**Year 1 Monitoring Report**

**MOCKINGBIRD SITE**

NCDMS Project # 100021 (Contract # 7185)

RE: Mockingbird Site: Year 1 Monitoring Report (NCDMS ID 100021)

**Table 14.**

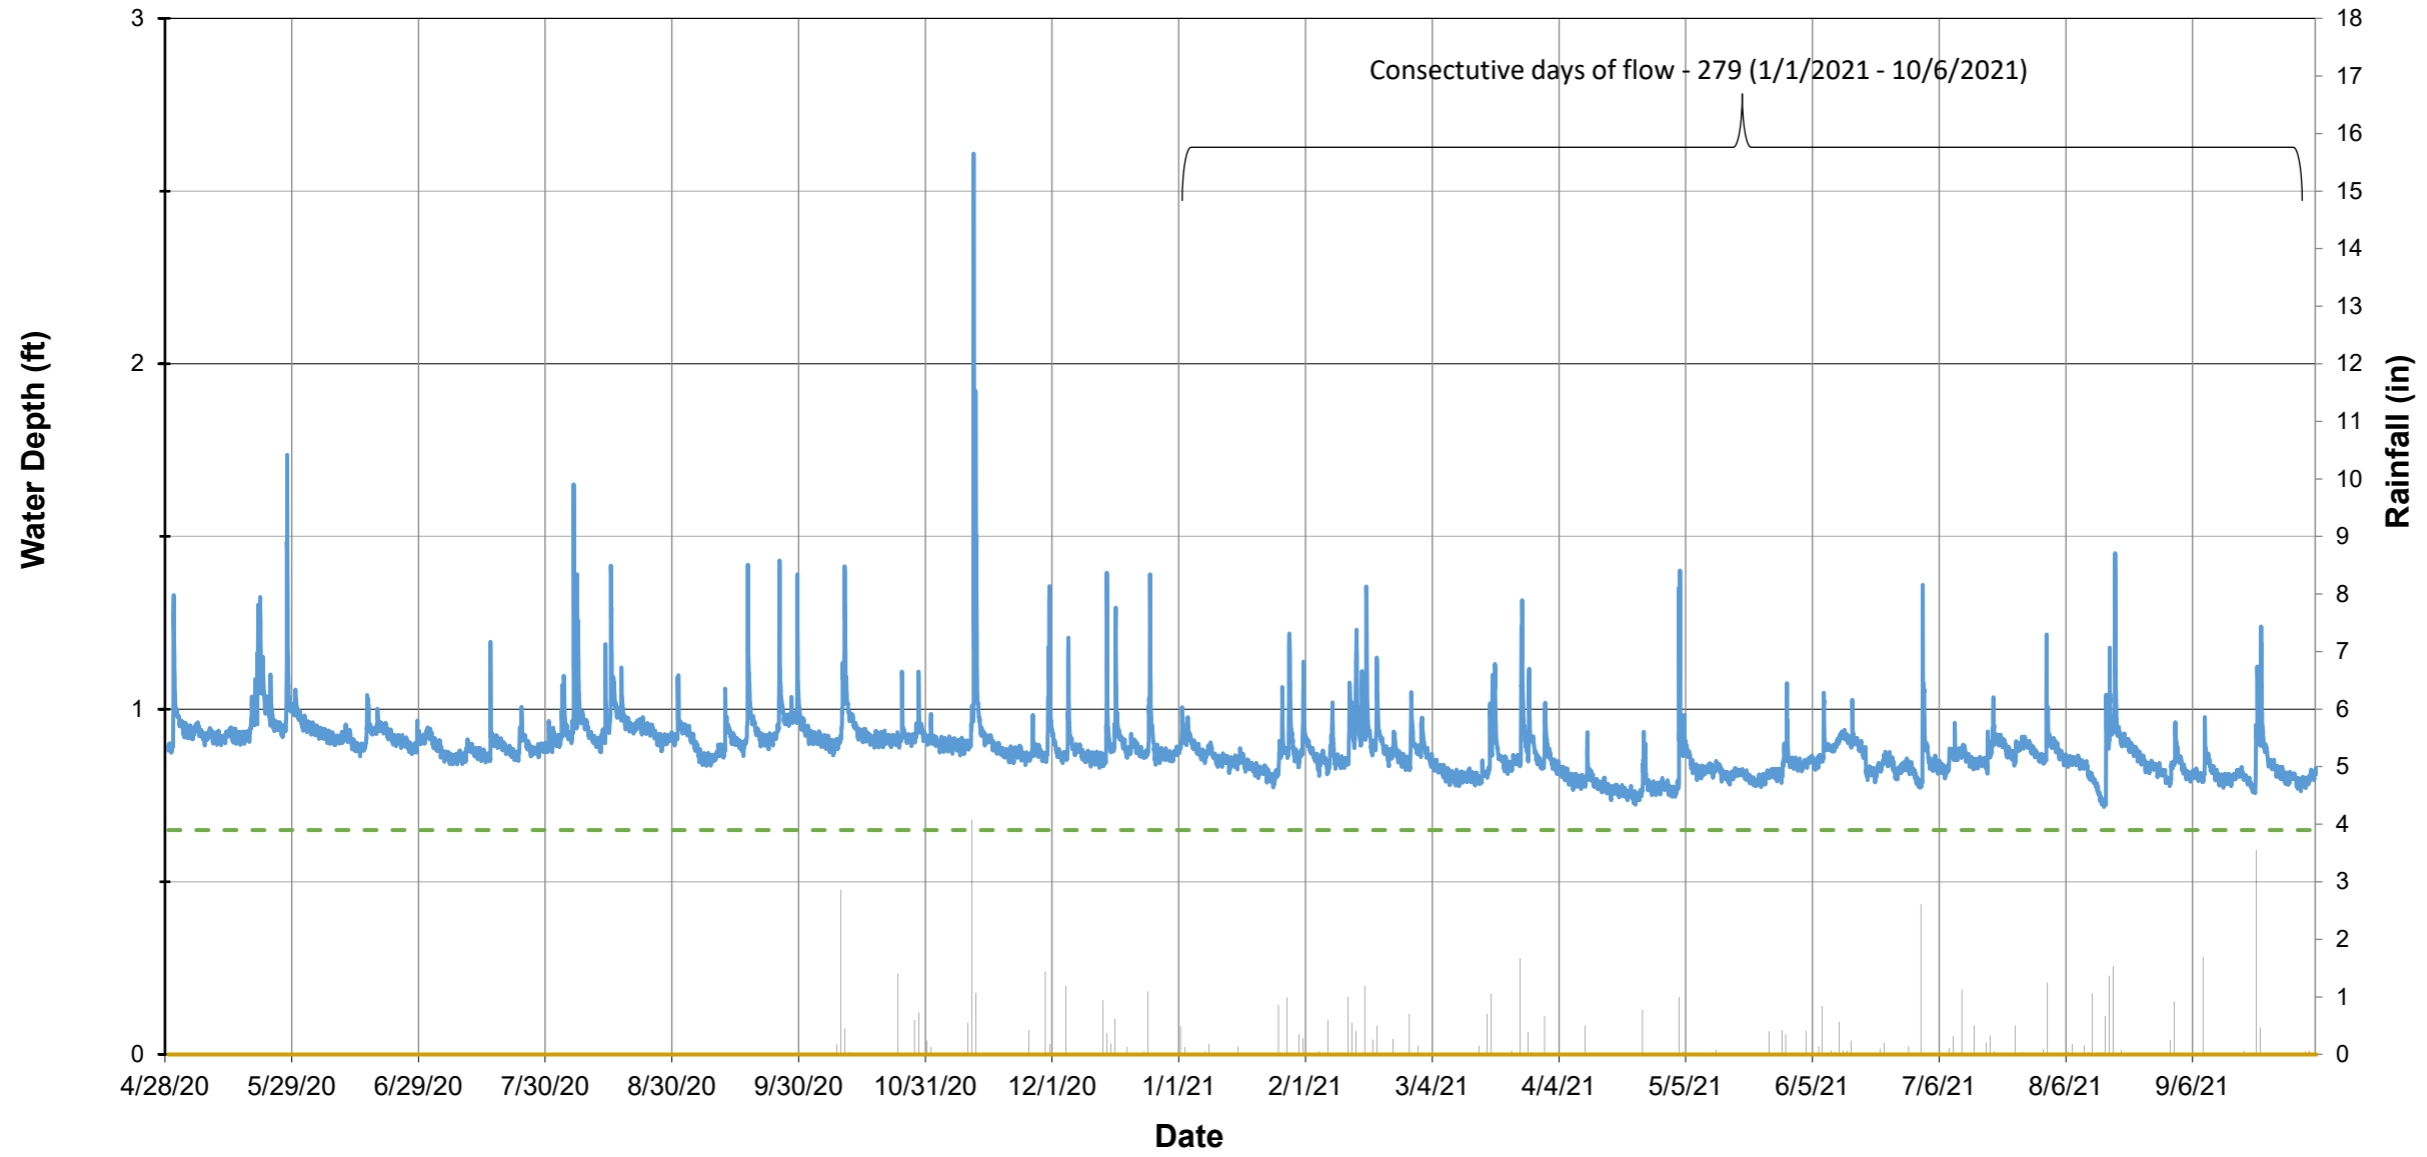
If possible, please indicate the consecutive days of flow on the flow gage graph, and show the corresponding period on the graph.

[Done. These are now included on the flow graphs.](#)
